U.S. NUCLEAR REGULATORY COMMISSION
REGION I

Report No. 50-317/85-03

Facility Name: Calvert Cliffs Nuclear Power Plant, Unit 1

Inspection Summary: Inspection on March 4-15, 1985 (Report No. 50-317/85-03)

Figure 6.7

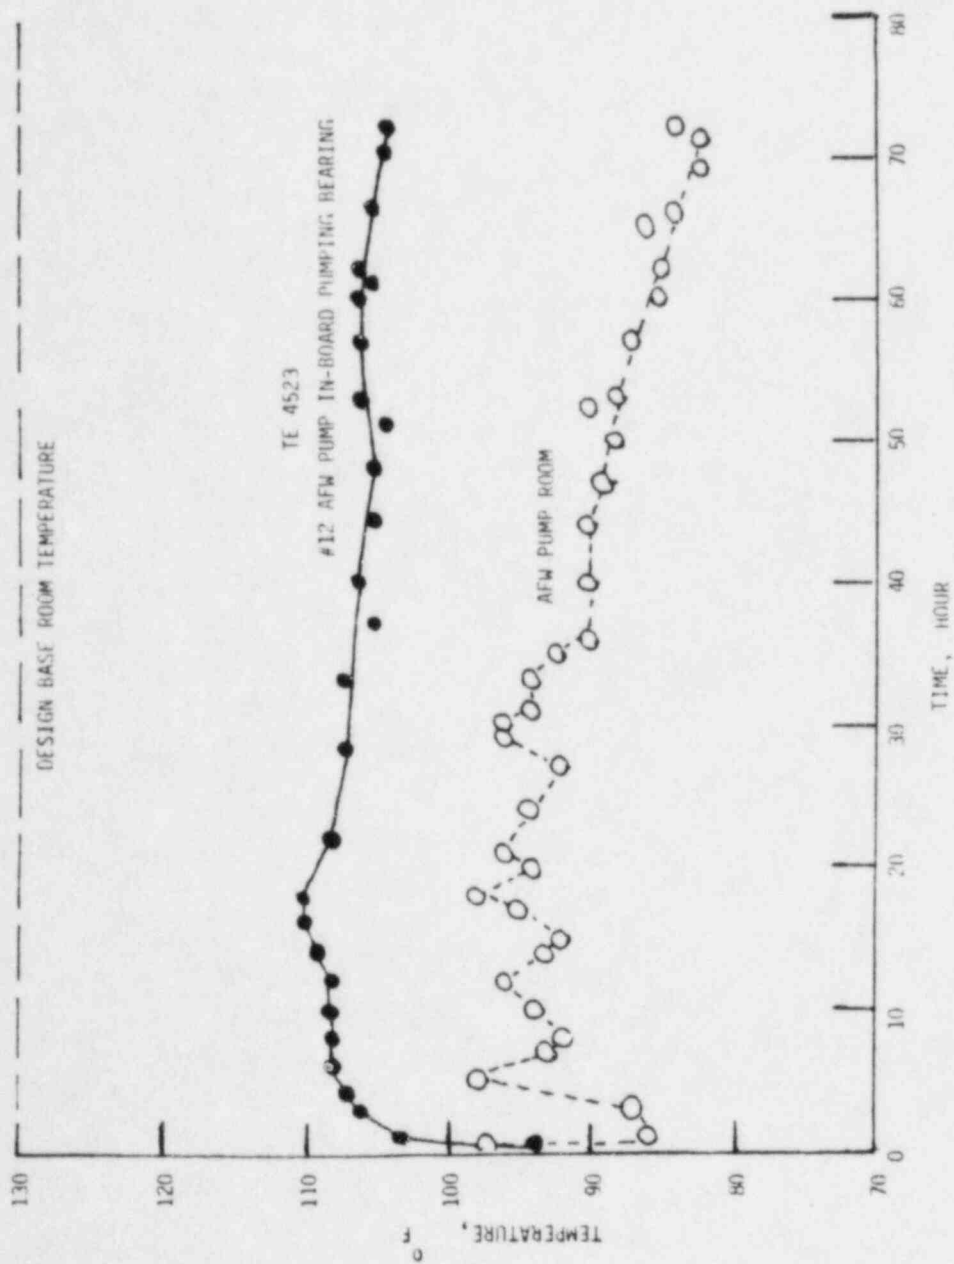
The licensee conducted a special 72 hour AFW Pump test (TSP-30) on January 8, 1980 to demonstrate room cooling, and to ensure that the equipment within the room would be compatible with the environmental conditions during the pump operations. The inspector plotted the test data as shown in the Figure 6.7 to understand the cooling characteristics.

In this test, the two doors leading to the main turbine bay were opened 15 minutes into the test. When the doors were opened, the room temperature quickly decreased by more than 12°F as shown in Figure 6.7 and oscillated for more than 20 hours until convective heat removal and air circulation stabilized. The bearing temperatures remained well within the operating limits. The following table summarizes the maximum inboard and outboard bearing temperatures observed during the test.

The bearing temperatures were monitored from the process computer CRT display in the control room. Based on these test results, it was concluded that the bearing temperatures remained within acceptable limits. However, the air circulation provided by opening the doors to the main turbine bay should be incorporated into the station emergency procedures. This was an example of the open item discussed in Section 6.9.
